PROJECT: Fusor Device				
TITLE: Machined KJL fixed flange				
APPROVED	SIZE	CODE	DWG NO	REV
CHECKED	B			
DRAWN William Butler 8/7/2026	SCALE 1:2	WEIGHT	SHEET 1/1

SECTION A-A
SCALE 1:2

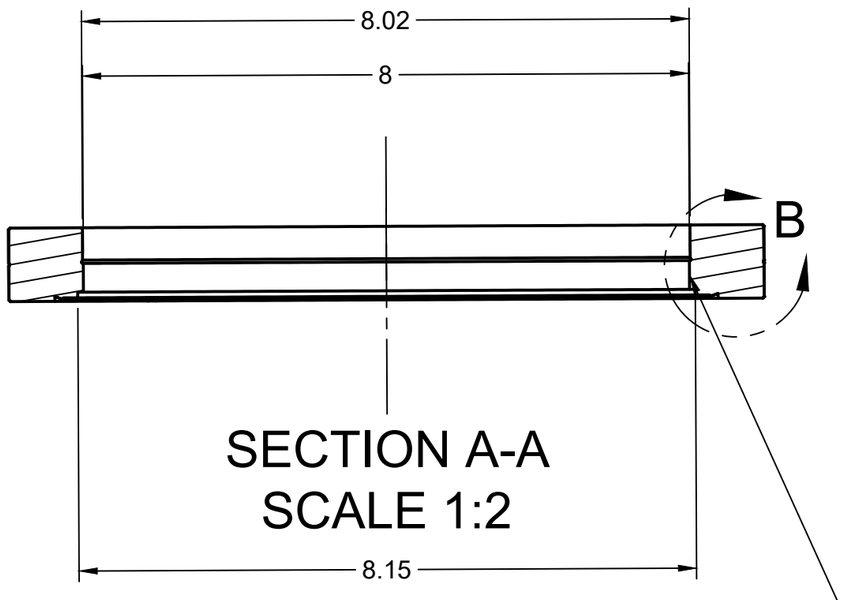
Inner diameter of bottom "lip" must be increased from 7.89" to 8" to maintain contact with steel hemisphere.

DETAIL B
SCALE 4:1

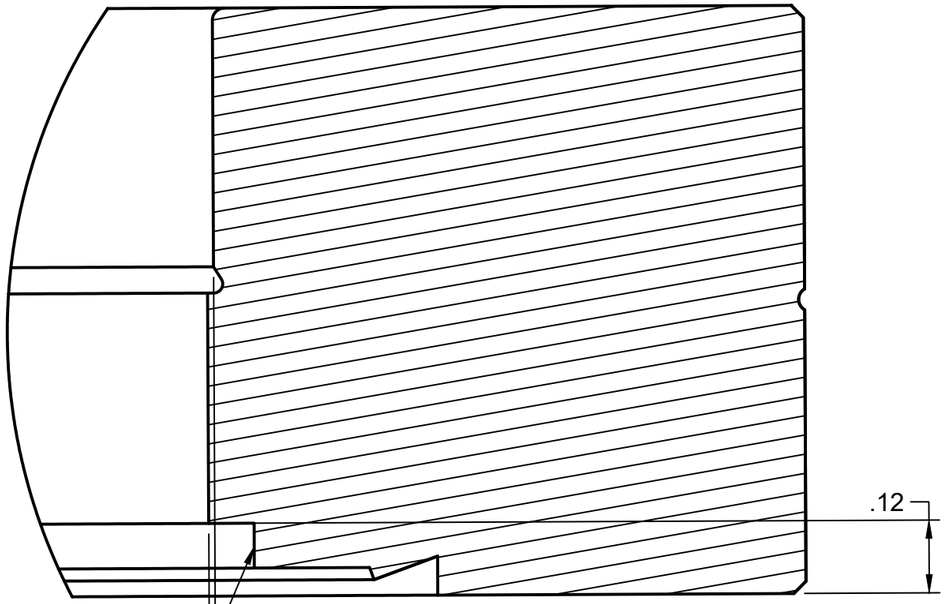
Machined "groove" width and height (shown here as 8.15" X .12") are viable for alteration. Designed as a relief groove for weld at bottom of steel hemisphere.
